Amendment Report

19-25 Balfour Street, Lindfield

In -fill Affordable Housing

SSD 82709458

Figure 5: Southwestern view of refined height plane (Source: Giles Tribe)

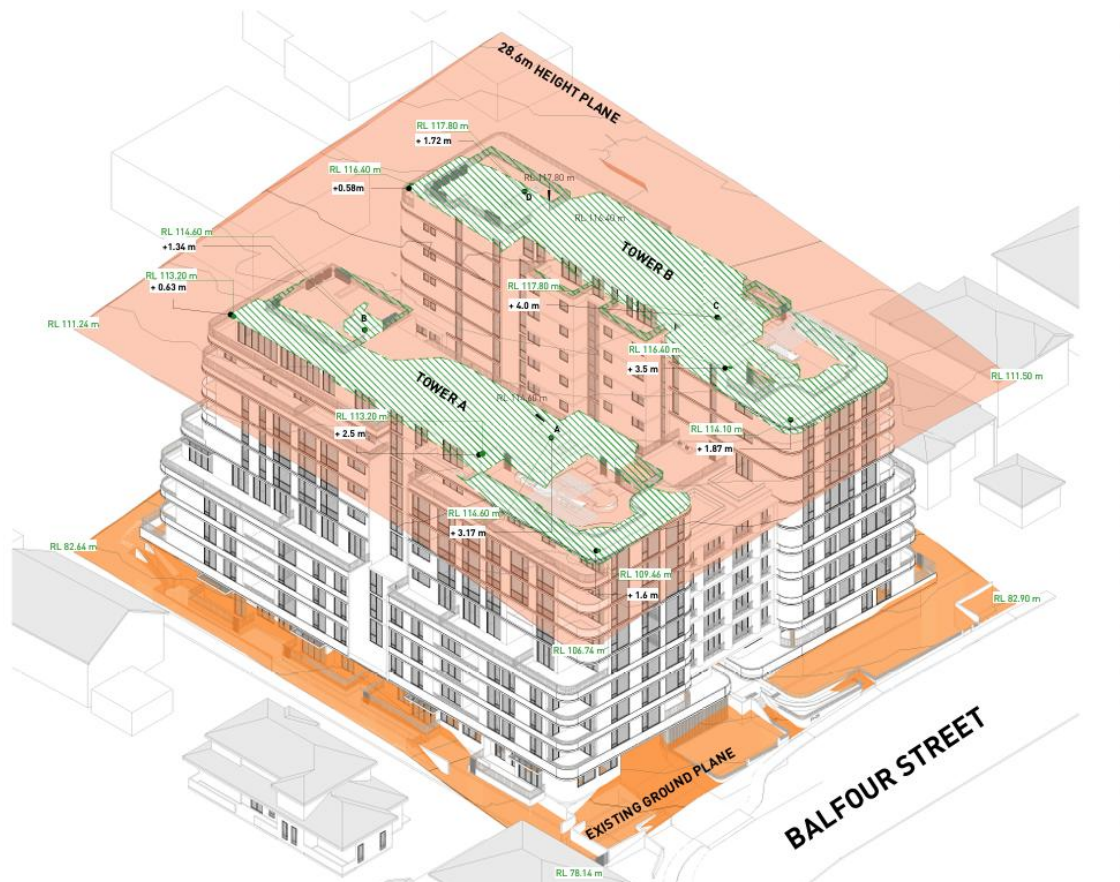
The most notable change is the increase in the central podium elements from four storeys to six storeys, together with refinements to the upper-level roof form and height plane. These changes redistribute built form within the building envelope and result in a more articulated podium and upper-level form.

The amendments also result in a minor reduction in the maximum building height, reducing from 32.7m to 32.6m. Notwithstanding the building height has been reduced significantly in the south-western corner from 4.1m to 1.6m. The height plane has been refined given the increased upper-level setbacks.

Figure 8 Communal Open Space Ground Floor (Source: GilesTribe)

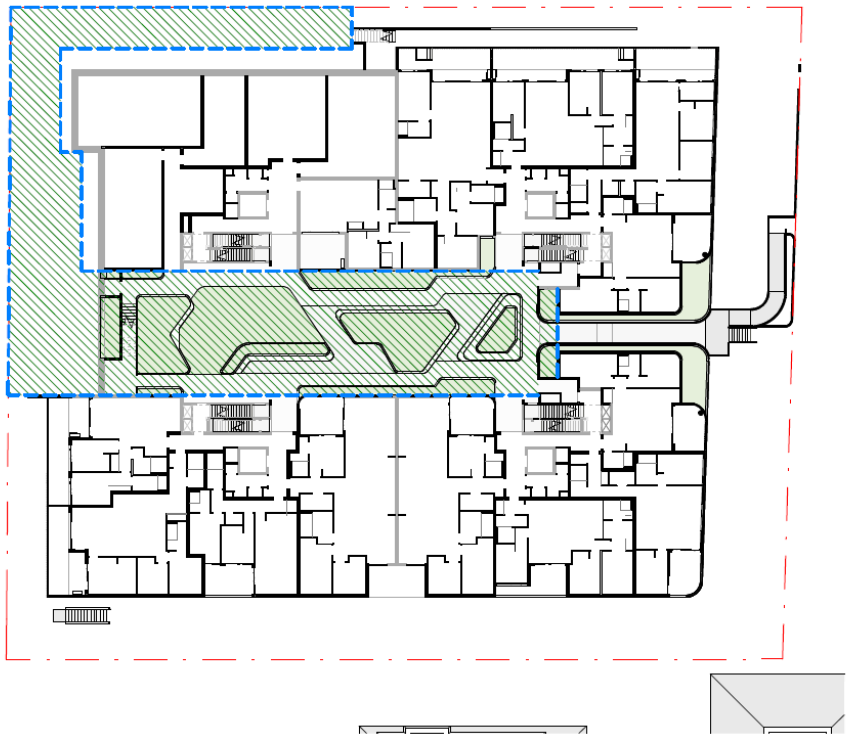
- primary communal open space is provided at Levels 8 and 9, totaling approximately 311m²
- secondary communal open space is retained at ground level and level 1, totaling approximately 890m²

The inclusion of additional COS at Levels 8 and 9 provides elevated communal areas with improved solar access while maintaining landscaped communal areas at the lower levels of development. The COS zones are shown in figures below:

Figure 10 Deep soil area (Source: Giles Tribe)

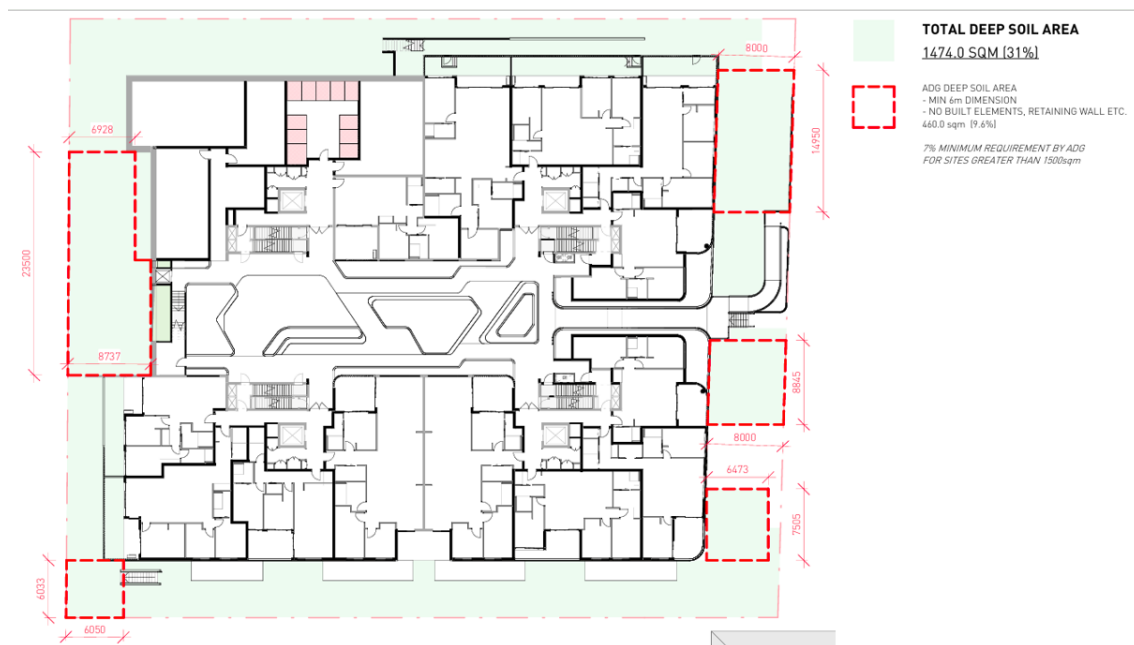
The amended proposal includes a minor increase in the provision of deep soil landscaping when compared with the exhibited scheme. See Appendix 8 for the updated Landscape Plan. The deep soil area has increased from 1,433.98m² (30% of the site area) to approximately 1,474m² (31%).

- Consolidates deep soil areas into larger and more functional planting zones, retention of trees 3 and 42 as identified within the Arboricultural Impact Assessment and the relocation of tree 39
- Improves the opportunity for canopy tree planting across the site
- Enhances the overall landscape quality of the communal and boundary planting areas

The revised landscaping layout provides more usable deep soil zones and is capable of supporting mature canopy planting. See figure below for deep soil zones.

Figure 13 Setbacks of Tower A and B (Source: Giles Tribe)

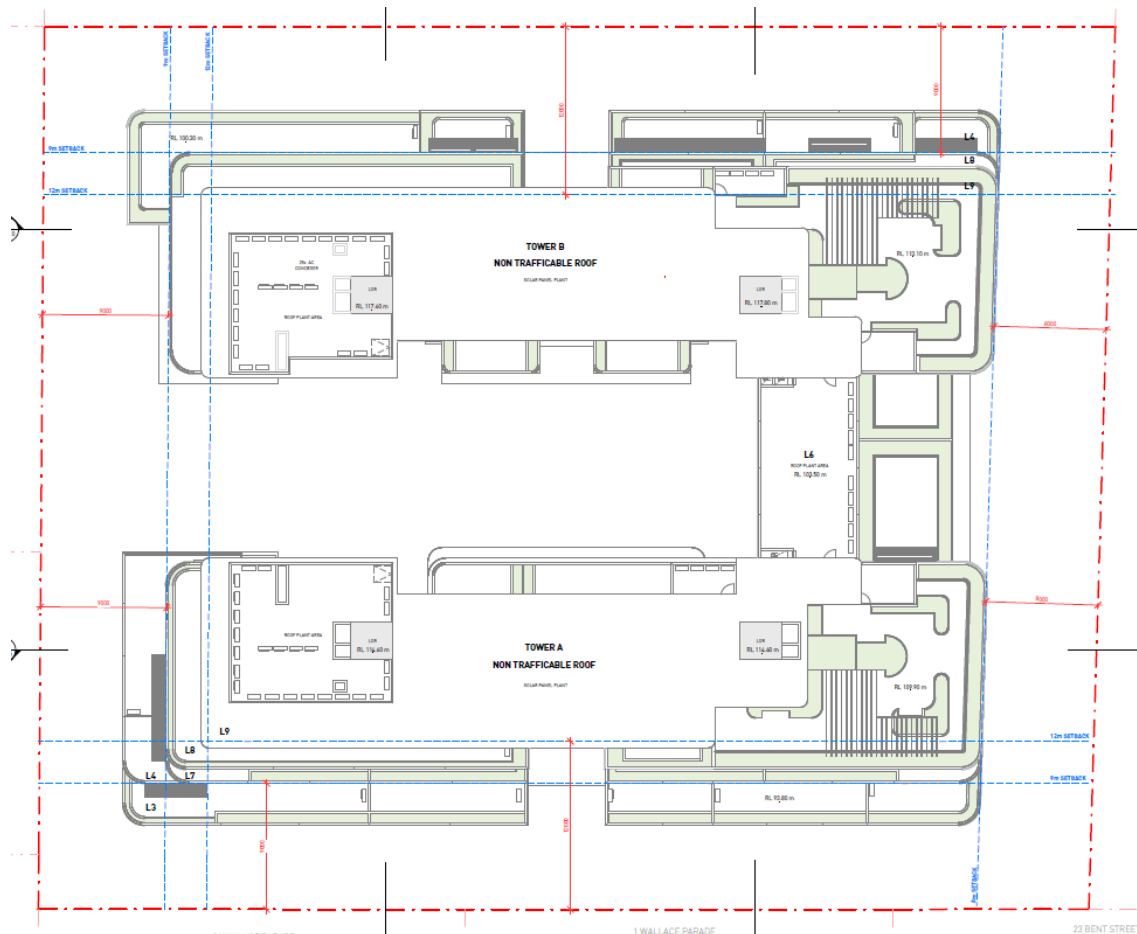
Importantly, the upper levels of the building now achieve 12m setbacks where required for buildings above eight storeys. This represents an improvement over the originally submitted scheme, which achieved only 9m setbacks at the upper levels. The setbacks of Tower A and B are shown in figure below:

The increased setbacks at the upper levels are achieved through stepping of the building envelope, which reduces the perceived bulk of the development and improves the relationship between the building and adjoining properties.

Figure 21 Communal Open Space solar access (Source: Giles Tribe)

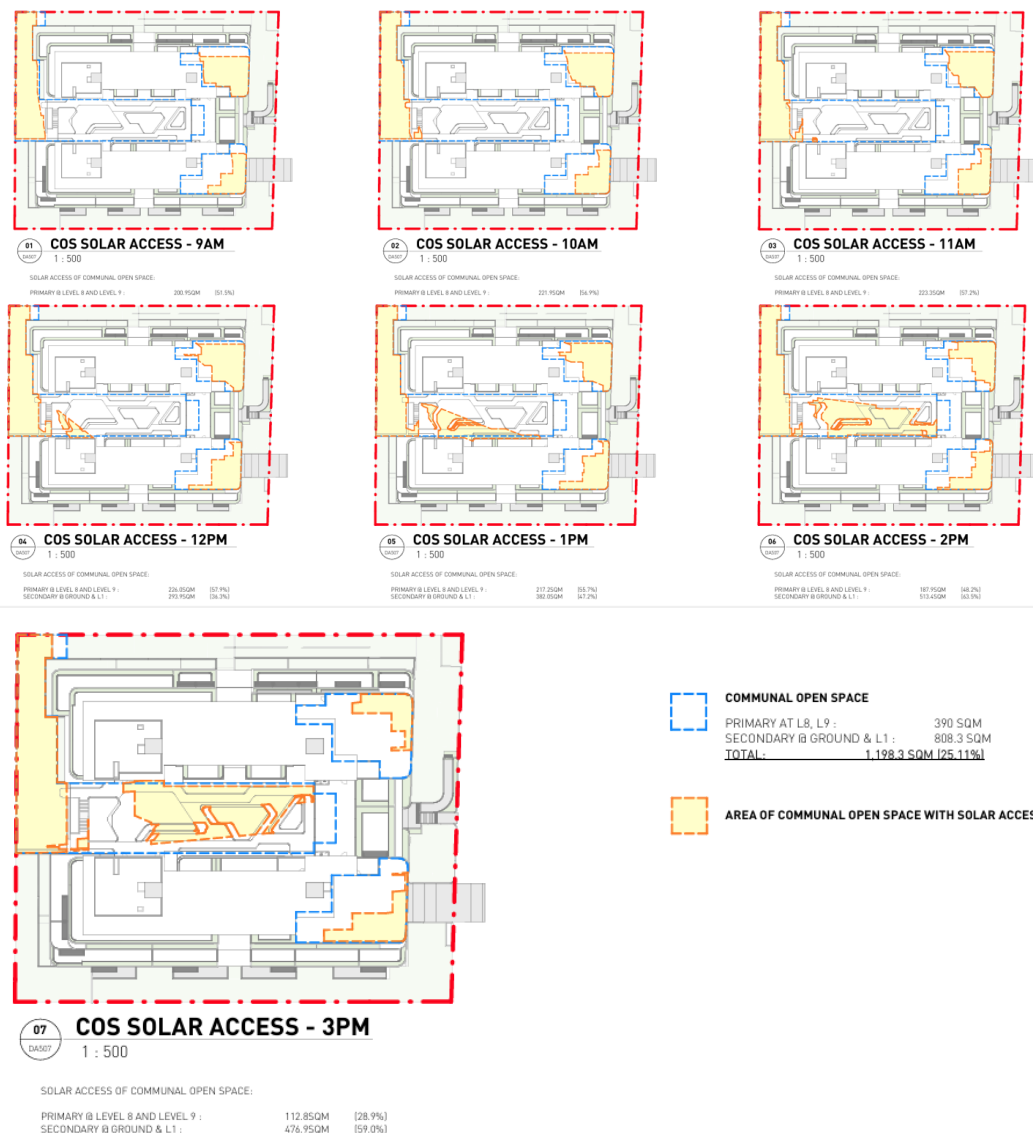
The refined building scheme increases the provision of COS provided at levels 8 and 9, providing additional opportunities for residents to access sunlight and outdoor amenity. The communal open space areas receive the minimum requirement under the ADG. The figures below provide COS solar access between 9 am and 3 pm.
